ADDENDUM NO. 1

**SEWAGE TREATMENT PLANT IMPROVEMENTS
AT
KUPUNA HOME O`WAIALUA**

HPHA JOB NO. 07-046-150-S

January 11, 2010

EXHIBIT 1C

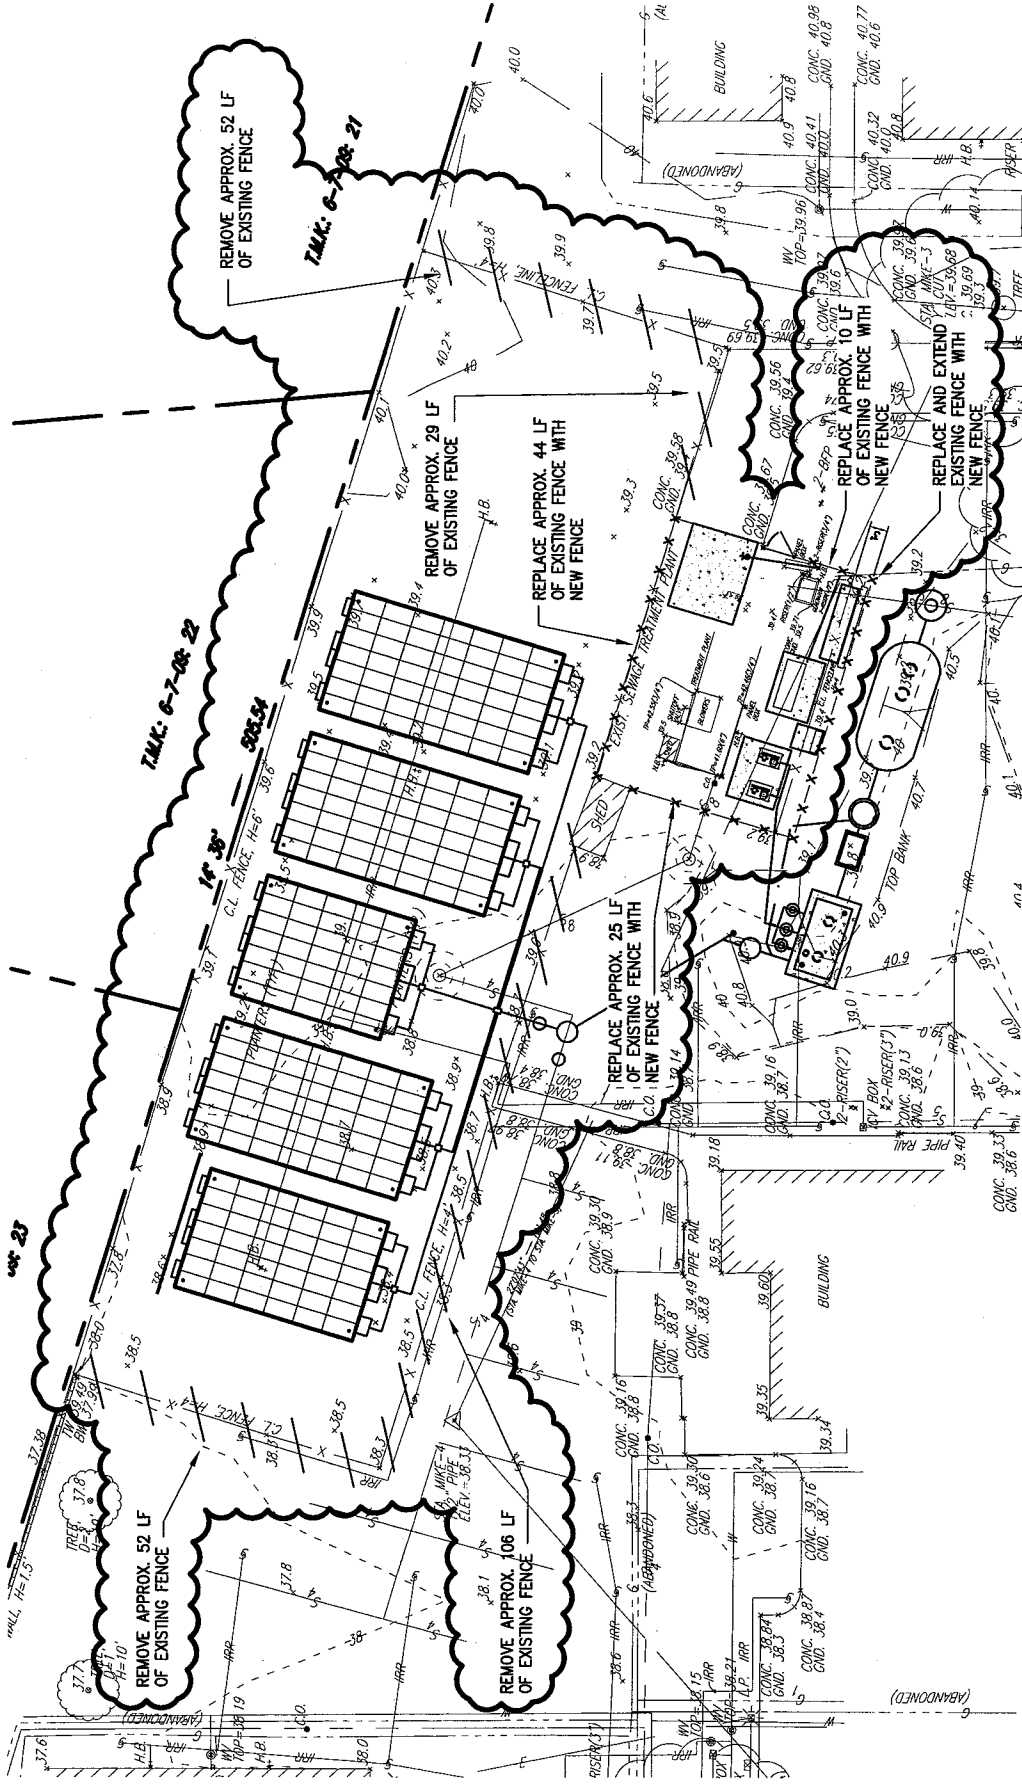
<u>Exhibit Number</u>	<u>Reference Drawing</u>	<u>Description</u>
1C	C-2	Revised Leaching Bed Inverts, Notes, and Root Barrier Installation
2C	C-2	Revised Fencing Improvements
3C	C-9	Revised Details

DESCRIPTION	REVISSED	LEACHING BED INVERTS & NOTES AND ROOT BARRIER INSTALLATION

1. THE COMBINED NEW LEACHING BED AREA SHALL NOT BE LESS THAN 3,369 SF

2. FOR LEACHING BED DESIGN DATA, SEE SHT. T-3
3. ALL LEACH FIELD DISTRIBUTION PIPING SHALL BE 4" PVC SENDER PIPE AND SHALL BE LAID WITH SLOPES SHOWN ON PLANS. ALL LEACH FIELD HEADER PIPING SHALL BE 4" PVC SENDER PIPE AND SHALL BE LAID LEVEL.
FOR LEACHING BED, PIPING, AND INSPECTION PORT DET., SEE (T-1) (T-2) (T-3)
4. THE DISTRIBUTION BOX DROP FROM INLET TO OUTLET SHALL NOT BE MORE THAN 2'.
5. ALL PORTIONS OF THE LEACH BEDS INCLUDING DISTRIBUTION BOXES, FILTER FABRICS, PIPING AND CHAMBERS SHALL MAINTAIN A 5' CLEARANCE FROM THE PROPERTY LINE.
6. ALL PORTIONS OF THE LEACH BEDS INCLUDING DISTRIBUTION BOXES, FILTER FABRICS, PIPING AND CHAMBERS SHALL MAINTAIN A 10' CLEARANCE FROM ALL TREES.

EXHIBIT 2C

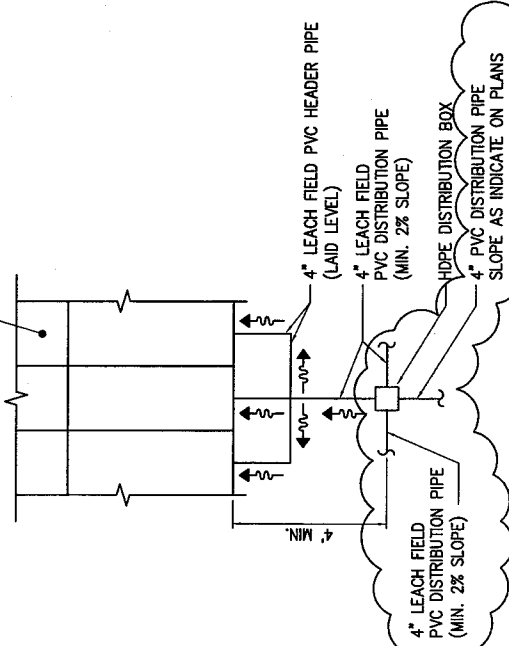
REVISED FENCING IMPROVEMENTS

Response: Removal and installation of new fencing and gates will be required around the new treatment plant controls system, blowers, electrical generator, and package storage shed (exist treatment plant location) as indicated in Addendum No. 1.

SCALE: NO SCALE	REFERENCE SHEET:	SEWAGE TREATMENT PLANT IMPROVEMENTS AT KUPUNA HOME O'WAIALUA
JOB NO: 07-046-1505	C-9	
EXHIBIT 3C	DATE:	REVISED DETAILS
3 OF _3_	1/11/10	
DESCRIPTION:

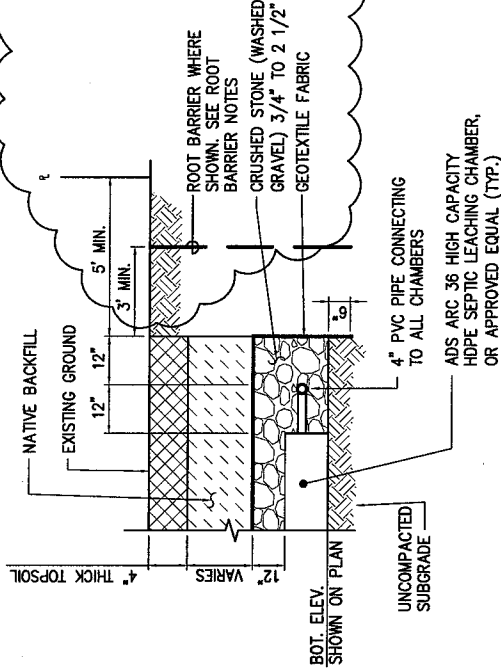
2 LEACHING BED PLAN
C-9 NOT TO SCALE

3 LEACHING BED END DETAIL
C-9 NOT TO SCALE

ADS ARC 36 HIGH CAPACITY
HDPE SEPTIC LEACHING CHAMBER,
OR APPROVED EQUAL (TYP.)

ROOT BARRIER NOTES:

1. ROOT BARRIER SHALL BE TY-AR BIO-BARRIER OR APPROVED EQUAL, INSTALLED IN ACCORDANCE WITH THE MANUFACTURER'S DIRECTIONS AND AS SHOWN IN THE PLANS. THE ROOT BARRIER FABRIC SHALL BE DELIVERED TO THE SITE IN SEALED CARTONS, STORED OUT OF DIRECT SUNLIGHT, AND INSTALLED AS SOON AS POSSIBLE AFTER THE CARTON IS OPENED.
2. FABRIC OVERLAP SHALL BE MIN. 3". USE SPIKES OR SOD STAPLES TO HOLD THE FABRIC IN PLACE.
